Title: Master Disconnect and Noise Kill Solenoid Replacement

Applies To: IC Bus Models, BE, CE Built Prior to April 2012, RE Built Prior to Jan 2010, All FE

Figure 2

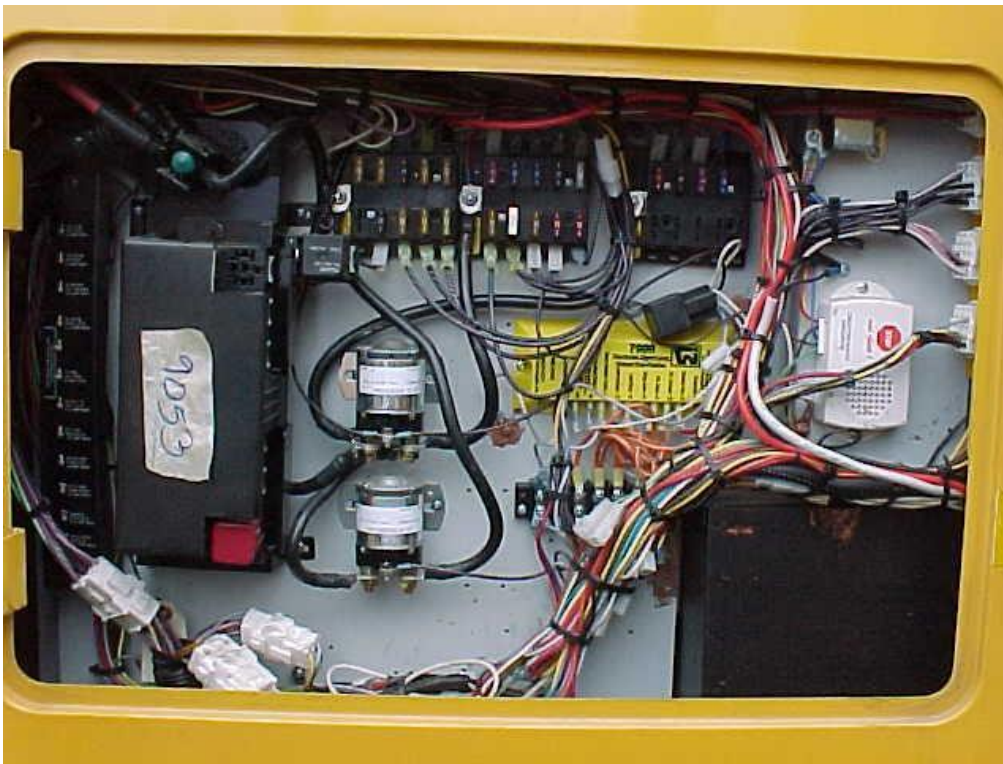
Possible mounting locations include reusing the right side solenoid original mounting holes, the original left mounting hole for the left side solenoid and drilling a new mounting hole for the right side as illustrated in **Figure 2** and **Figure 3**. A 1/8" hole should be drilled for the new mounting hole. Reconnect the cables to the new solenoids, left to left stud (B+ Feed), center (Ignition Feed) to center stud, and right (Fuse Block Feed) to right stud.
